Planning Application Number: 3/2022/0632

Thank you for your letter dated 8<sup>th</sup> July 2022 regarding the proposed demolition of Pendle Mill for the creation of a 70-bed care home. Having taken time to review the documents on the planning application, we have some questions and concerns we would like to raise.

Appendix 1 – Annotated to show significance of height in comparison to 25 Pendle Rd and dormer extension to rear of roof of the same property.

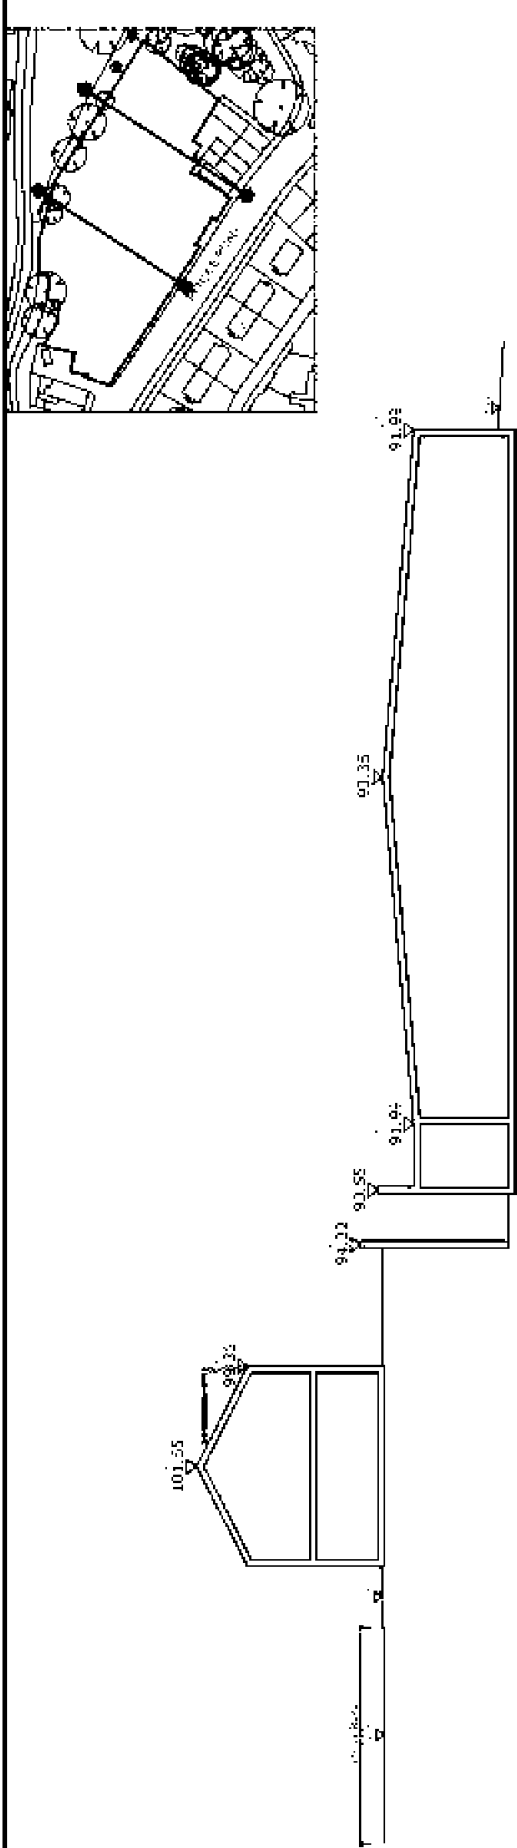
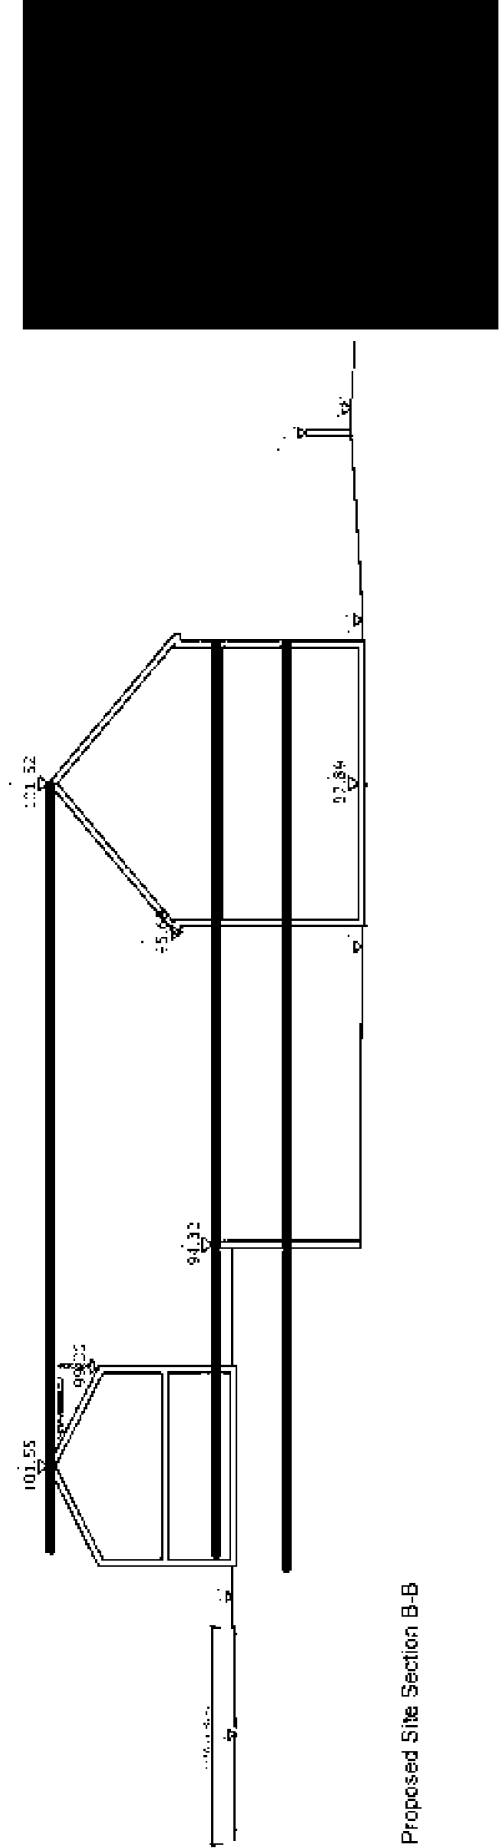
The elevation of the proposed building (as per Site Section BB) shows the new ridge height as 101.52m, and [REDACTED] 101.55m. The proposed ground floor height of the new building is shown as 87.89m, and the street level [REDACTED] sits at 93.40m. As these two starting levels have a difference of 5.61m (with the new building being lower), we would like to understand why the new building is so tall.

The pitch of the roof on the proposed building appears to be where most of this height is. [REDACTED] is 2.25m from eaves to ridge, with the proposed building being 5.84m from eaves to ridge. Is this height and steep roof pitch necessary?

Please refer to Appendix 1 at the end of this letter to see this represented on Site Section BB.

The plans don't show that [REDACTED] and those of our two immediate neighbours, have dormer roof extensions at the rear of the property. This, in addition to [REDACTED] new property. As mentioned on page 13 of the Design and Access Statement, this would result in reduced privacy for the residents of the care home.

Appendix 1 also shows the location of [REDACTED] property.

### Appendix 3 Concerns highlighted by the developers regarding traffic and the overlooking of the property, as well as a mention of using existing access points to reduce disruption.

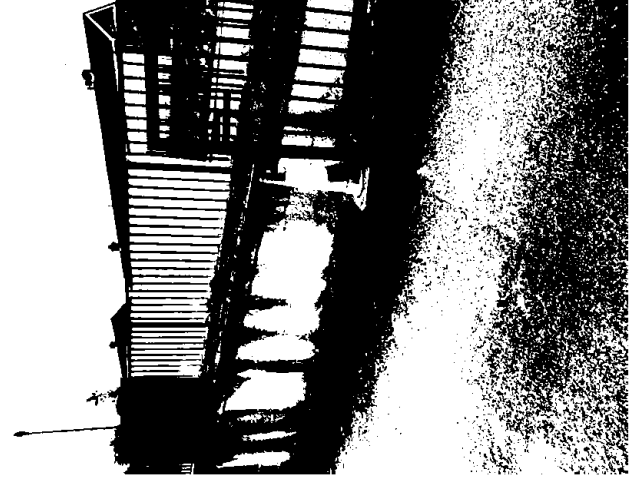
With the existing traffic and parking issues, the matters of access and parking are causes for concern to us. Appendix 3 shows the concerns highlighted by the developers regarding traffic and the aforementioned overlooking of the property, as well as a mention of using existing access points to reduce disruption.

Appendix 4 Showing the area proposed for access onto Pendle Road, including existing gas main.

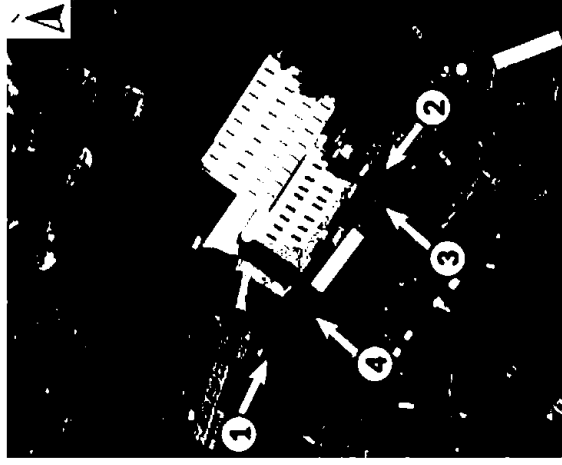
1. According to Page 20 of the Design and Access Statement, the proposed access would open directly onto Pendle Road, at the same level as the road. As can be seen on the attached photographs and excerpt from Page 8 of the D & A statement (Appendix 4), the current wall alongside the road varies up to 2.5m high and includes a gas main. How would the access road and the main road be made to be on the same level? Would significant works need to be carried out in order to make this happen?

Appendix 5 An excerpt of page 22 of the Design and Access Statement mentioning 'Thomas Street'

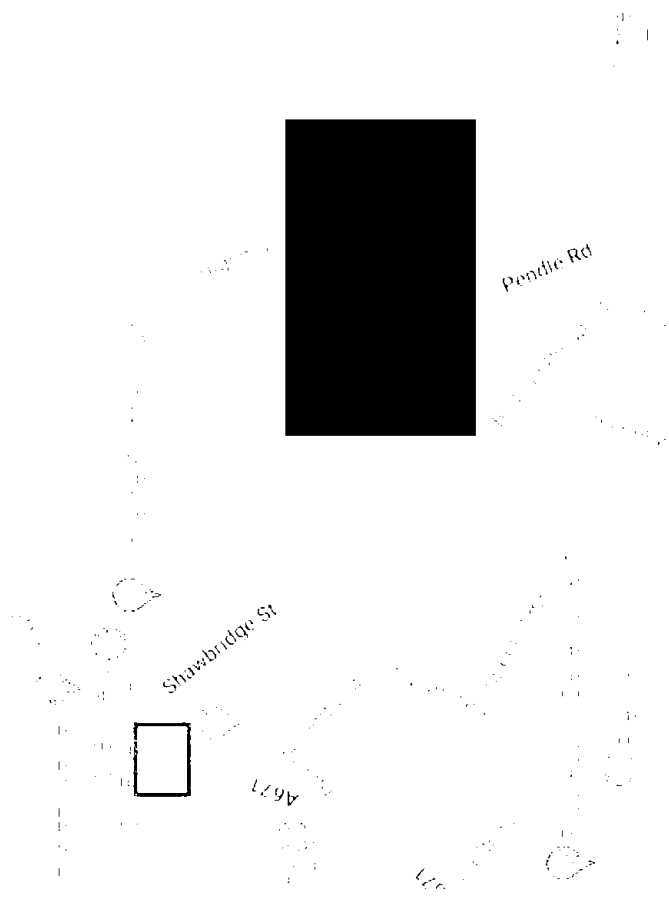
The Design and Access Statement – Appendix 5 – also references (on Page 22) a ‘Thomas Street’ when discussing access points. I have thus far been unable to find another reference to Thomas Street within the Design and Access Statement or any of the other documents. Is this an error in the paperwork, are we missing this reference within the plans or is a new street being created/named within the site?
